SUBJECT: Duke Energy Corporation

Oconee Nuclear Station Units 1, 2, & 3
Docket Nos. 50-269, 50-270, 50-287

Nuclear Quality Assurance Program
Amendment 29

Pursuant to 10CFR50.54 (a) (3) and 10CFR50.71 (e), attached is Amendment 29 to the Duke Energy Corporation Topical Report, Duke-1-A, *Quality Assurance Program* (hereafter referred to as Topical Report). Amendment 29 includes organizational changes, administrative and editorial changes.

Figure 17-2 Duke Energy Corporation Corporate Organization

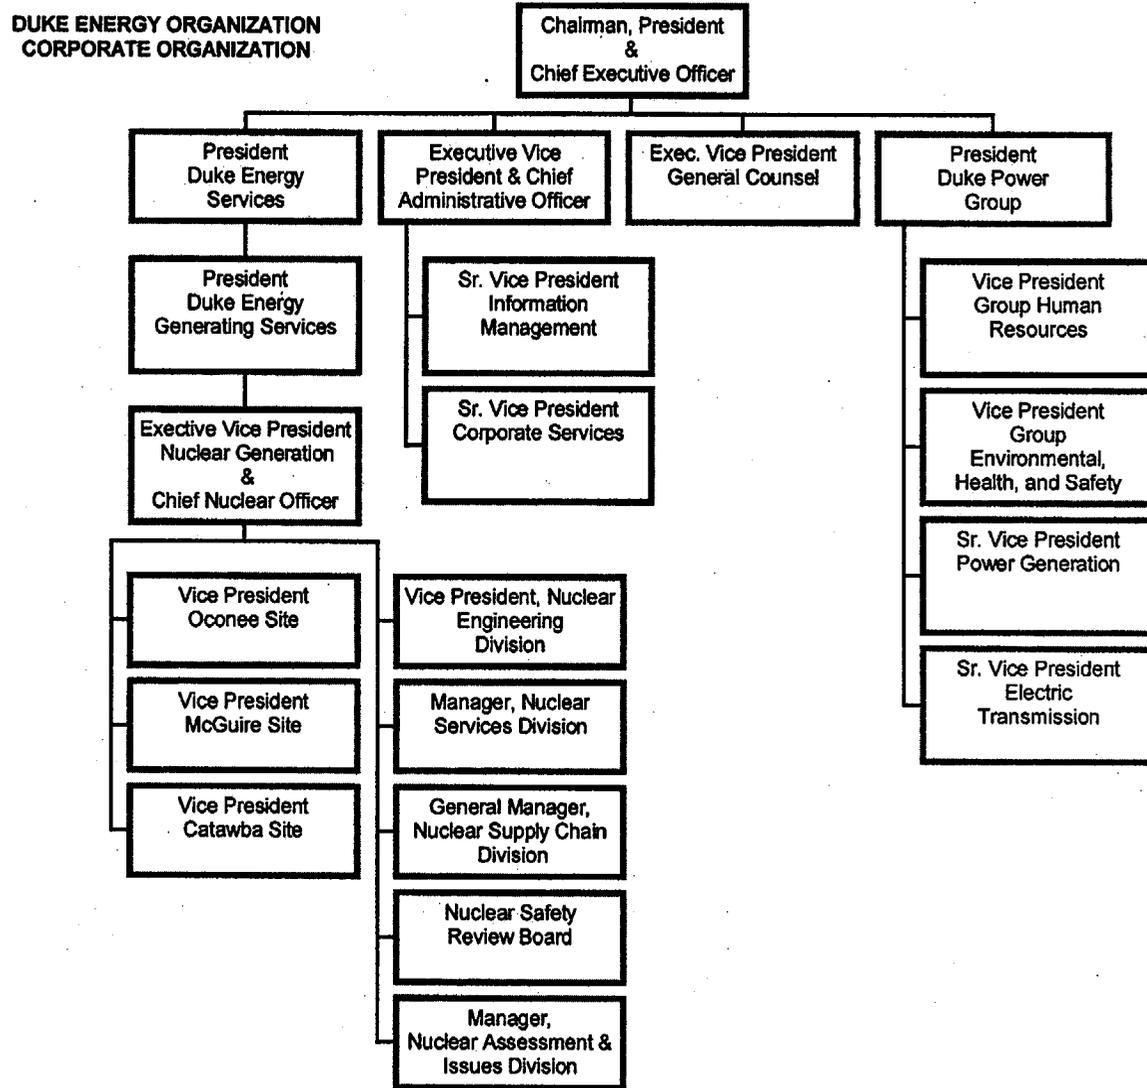
8. **Figure 17-2 Corporate Organization**, revised the organization to reflect corporate organizational changes.
9. **Figure 17-3 Off-Site Organization**, revised chart to reflect corporate organizational changes.
